# ADDENDUM NO. 1

January 21, 2016

## CRAWFORD STREET RECONSTRUCTION 14<sup>TH</sup> STREET TO 17<sup>TH</sup> STREET BOONE, IOWA

SHEET NO.  
**B.01A**

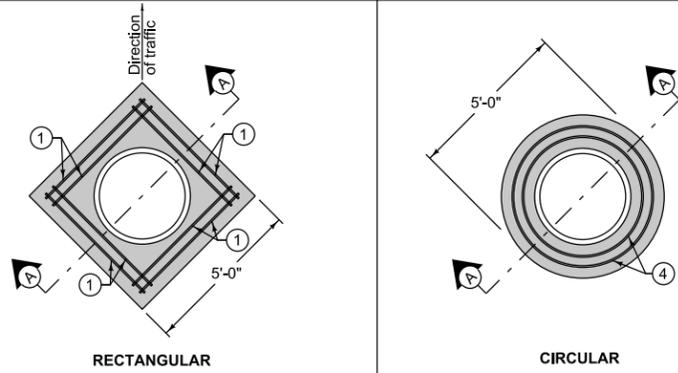
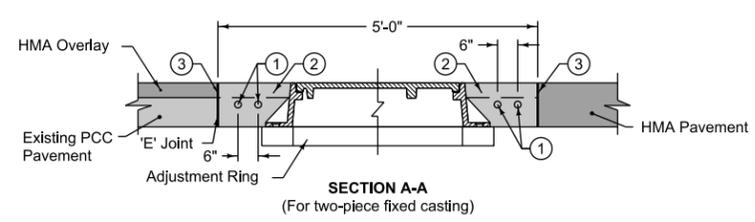
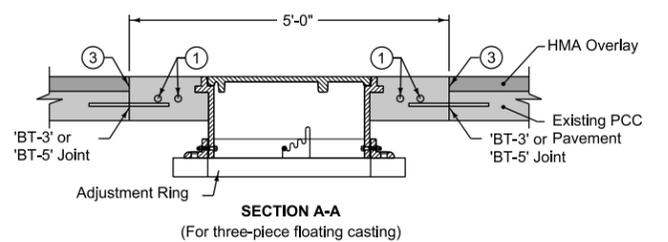
- 1.) Add plan sheet B.01A – HMA PAVEMENT DETAILS showing typical cross-section and details for Alternative Bid No.2 to the Plans.
